Field campaign

Topic	Convertible Roof - Revised Clip Arrangement - C Flap Bowden Cable (SC13/12)
Market area	Worldwide Bentley (1WBE)
Brand	Bentley
Transaction No.	2033508/3
Campaign number	E788
Note	E788
Type	E788
US code

Figure 1

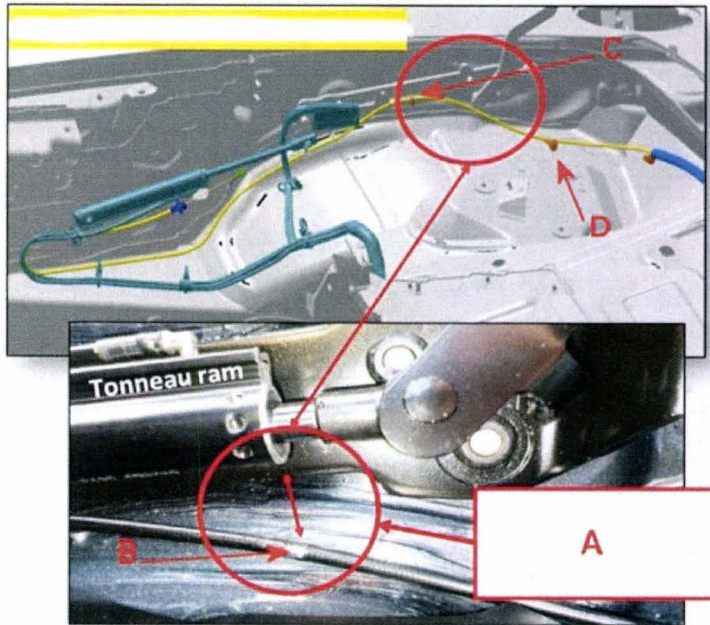
A potential compression point has been identified between the tonneau cover hydraulic ram and the C flap Bowden cable as it routes under the tonneau cover drive system (see Figure 1). A revised clip arrangement has been specified to avoid this compression damage. In severe cases the damage to the Bowden cable is such as to impair correct operation of the C flap, therefore a test of the C flap function is required to ensure the Bowden cables are serviceable before implementing the revised clip arrangement

- Figure 1 details the original routing and single cable tie (C) securing the Bowden cable (shown in yellow). The detail at point A shows the potential contact point between the tonneau cover hydraulic ram and the Bowden cable. The actual contact takes place when the tonneau is almost closed and therefore the close proximity of the hydraulic ram and the Bowden cable cannot be seen when viewed with the tonneau cover in a transient position. Detail B shows, in this case, a section of the outer sheath of the Bowden cable that has been removed by repeated contact with the ram. Note: as long as the system has passed the C flap function test then the absence of some of the outer sheath is not sufficient grounds to change the cables

All affected vehicles require a C flap function check to ensure correct operation before either applying the revised clip arrangement or in the case of failed function test refer to TPI 2033467 C flap Bowden cable replacement

Figure 1

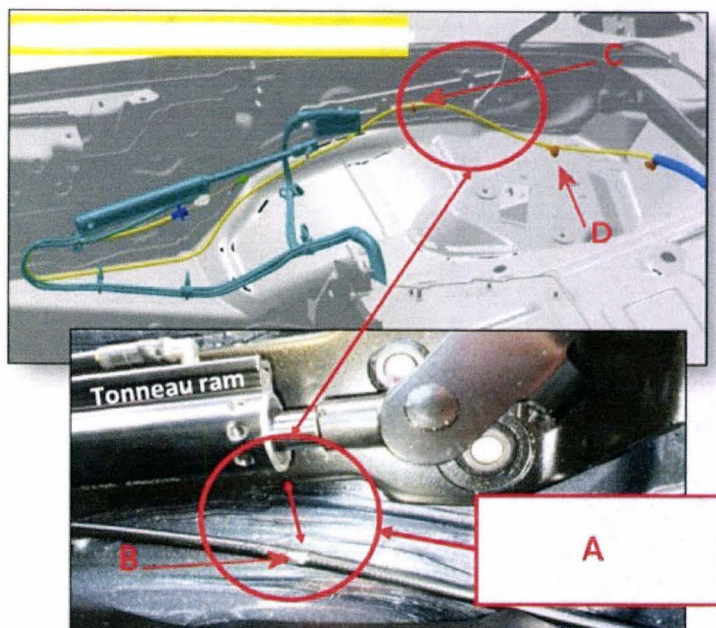
A potential compression point has been identified between the tonneau cover hydraulic ram and the C flap Bowden cable as it routes under the tonneau cover drive system (see Figure 1). A revised clip arrangement has been specified to avoid this compression damage. In severe cases the damage to the Bowden cable is such as to impair correct operation of the C flap, therefore a test of the C flap function is required to ensure the Bowden cables are serviceable before implementing the revised clip arrangement

- Figure 1 details the original routing and single cable tie (C) securing the Bowden cable (shown in yellow). The detail at point A shows the potential contact point between the tonneau cover hydraulic ram and the Bowden cable. The actual contact takes place when the tonneau is almost closed and therefore the close proximity of the hydraulic ram and the Bowden cable cannot be seen when viewed with the tonneau cover in a transient position. Detail B shows, in this case, a section of the outer sheath of the Bowden cable that has been removed by repeated contact with the ram. Note: as long as the system has passed the C flap function test then the absence of some of the outer sheath is not sufficient grounds to change the cables

6. With the tonneau cover still held in the vertical position, support the tension bow with a suitable prop taking care not to damage any trim (see figure 6)
7. Remove the original cable tie securing the Bowden cable (C) to the tonneau cover drive system and discard the clip securing the Bowden cable at point D, securing point D is not used with this revised clip arrangement (see Figure 1)

Figure 3

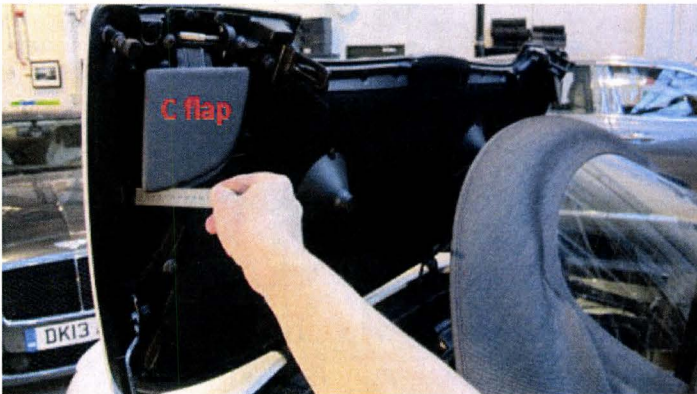
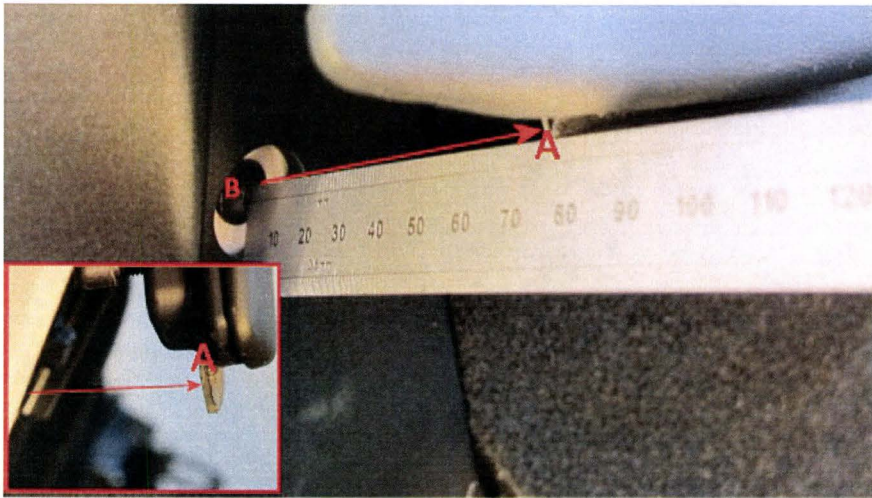
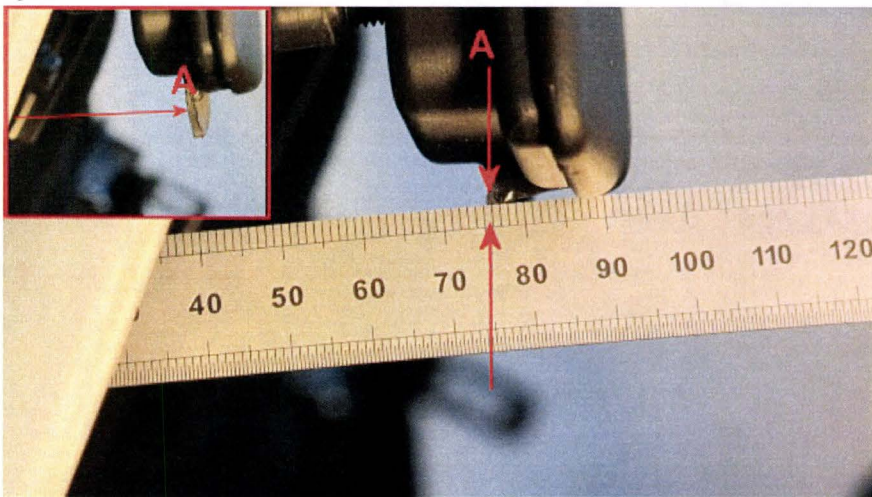
5. Referencing figures 3, 4 and 5 take a measurement between point (A), C flap obscuration lip, and (B), tonneau brightware securing bolt head. The correct specification for this measurement is 74mm to 90mm. If this measurement is not to specification or the C flaps are out of synchronisation or judder during operation then refer to TPI 2033467 to carry out C flap Bowden cable replacement. If the C flap is to specification then perform the revised clip arrangement

Figure 7

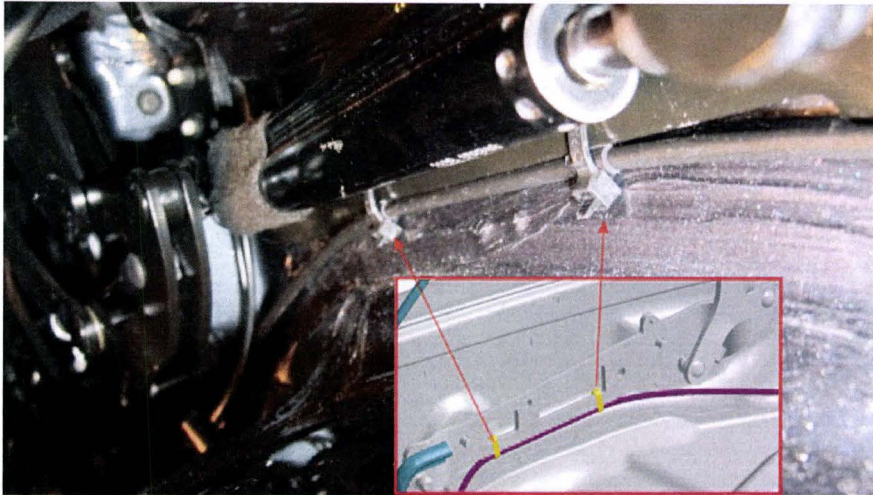
8. Referencing figure 7 secure the Bowden cable to the tonneau cover drive system using two cable ties. Ensure the Bowden cable is retained underneath, along the bottom of the bracket, where it cannot come into contact with the hydraulic ram. It may be necessary to temporarily release the Bowden cable from other retaining clips to gain sufficient length to enable the two new cable ties to be attached.

Figure 8

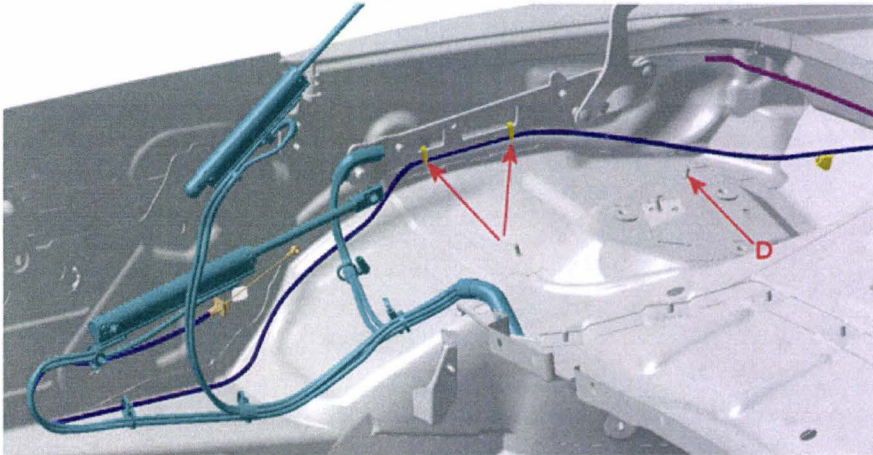
9. The final route and clipping arrangement is detailed in Figure 8. **Note:** The original stud and clip position previously securing the Bowden cable at point D is not to be used with this new arrangement
